# Certificate of Appropriateness

2555 N. LAKE DR. North Point North Historic District

PTS ID 111411 COA Reclad Exterior

Pedestrian View traveling north - showing half wall to be renovated

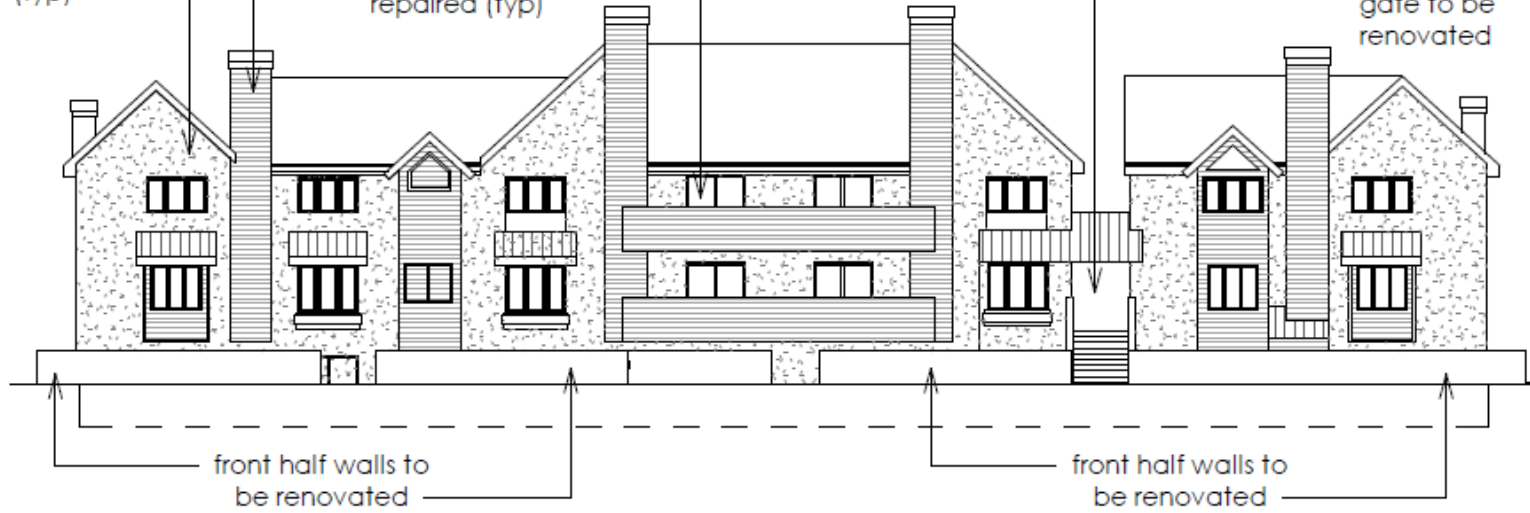
Existing entry gate area to be renovated

EFS to be replaced (typ)

cedar trim to be repaired (typ)

new patio doors + windows to match existing (typ.)

front entry gate to be renovated

Rear - North West

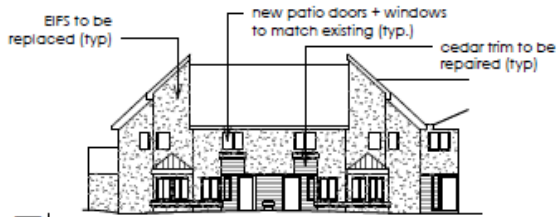
EFS to be replaced (typ)

cedar trim to be repaired (typ)

new patio doors + windows to match existing (typ.)
